Flight Procedures Cover Page	Task Action: Abbreviated Amendment	Task Type: Textual DP	Estimated Chart Date: 09/08/2022	APWS Task ID: 48AF6580DF224FD19868BC7094A46E70	APWS Project ID: ECF7DB5828CC4334B590F959A9F11B52
Procedure: TAKEOFF MINIMUMS AND ODP AMDT 2A		Enroute: YES	Specialist: Dumar, Ralph		Agreement Number:
Airport ID: KAKR		Airport City: AKRON			State: OH
Facility ID:	Facility Type:	Flight Inspection Remark Type:			
<p>Procedure Comments: PROCESSED IAW TECHNICAL SUPPORT GROUP (AJF-17) MEMO DATED 07/07/2021, SUBJECT: GUIDANCE FOR PROCEDURAL CHANGES REQUIRING FLIGHT INSPECTION/VALIDATION</p> <p>APPROVAL LETTER: RWY 25 DEPARTURE - 705 FT/NM CG REQUIRED KAKR: PENDING DATA USED. REMARKS: RWY 01/19 DECOMMISSIONED. CONTACT ALLAN WILL, 405-954-6103</p>

Subject: Approval Request: AKRON FULTON INTL (KAKR), Takeoff Minimums
and (Obstacle) Departure Procedures, Amdt. 2A

Takeoff Minimums and (Obstacle) Departure Procedures, Amdt. 2A
AKRON FULTON INTL (KAKR), AKRON, OH

KAKR
Akron Fulton Intl
Akron, OH
Textual Departure Rwy 25
Amdt 2A
1:100,000

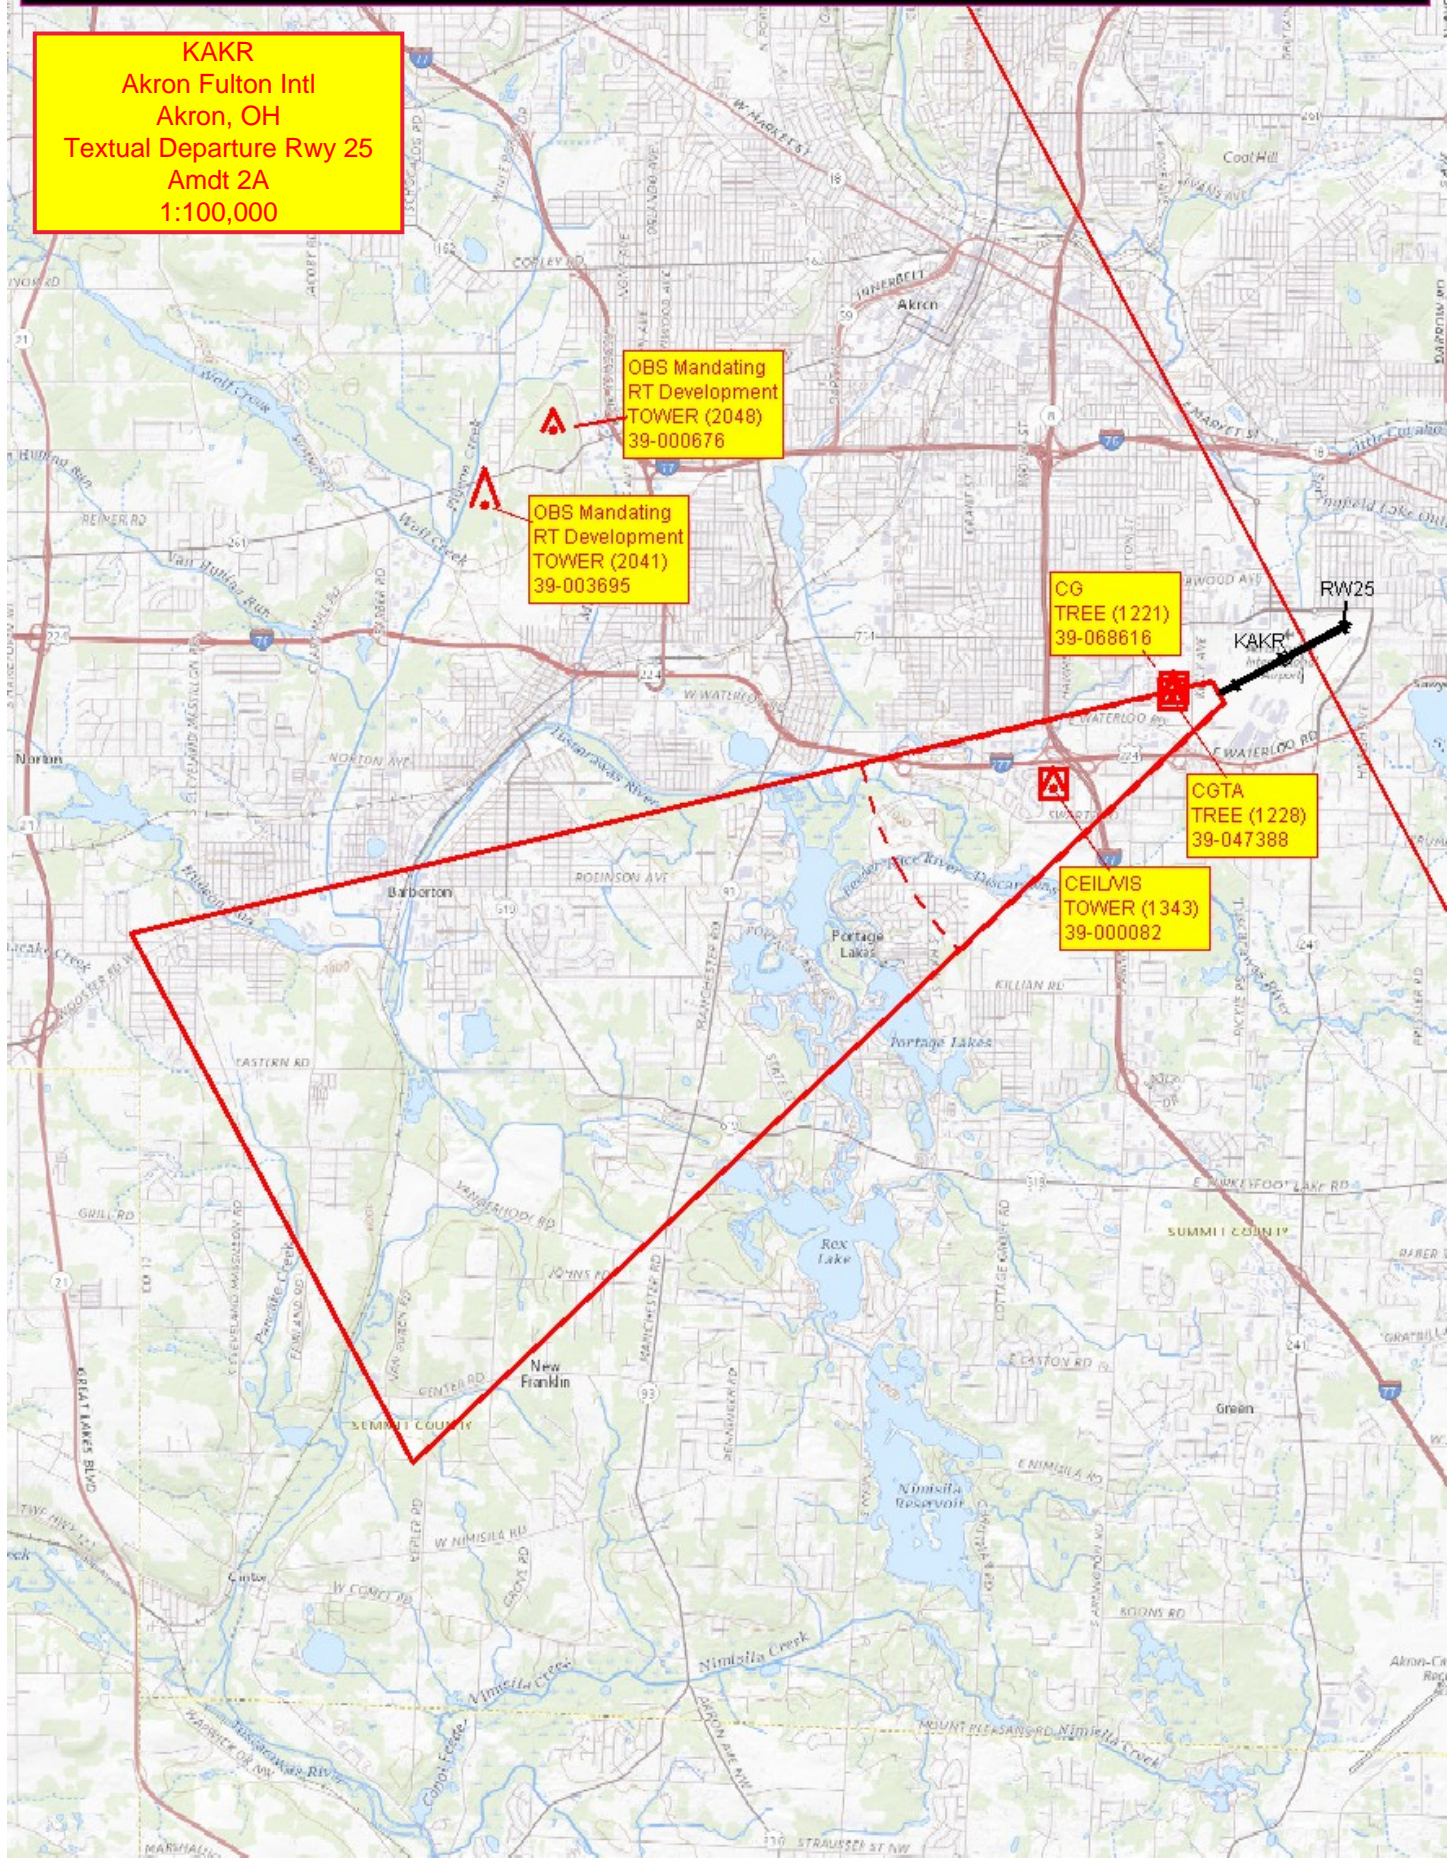
Takeoff from RWY 25 requires a 705 ft/NM climb gradient to ensure clearance from a 1221 FT MSL tree (39-068616) 410200.11N/0812906.02W, located 1745.10 feet from DER. The published departure was previously evaluated in IAPA, resulting in a 685 ft/NM climb gradient to clear the same controlling obstruction.

Pilots will also have the option to see and avoid the obstacle when ceiling/visibility are 300 - 1 5/8 SM.

Request approval to publish a 705 ft/NM climb gradient to 1500 for the Rwy 25 departure.
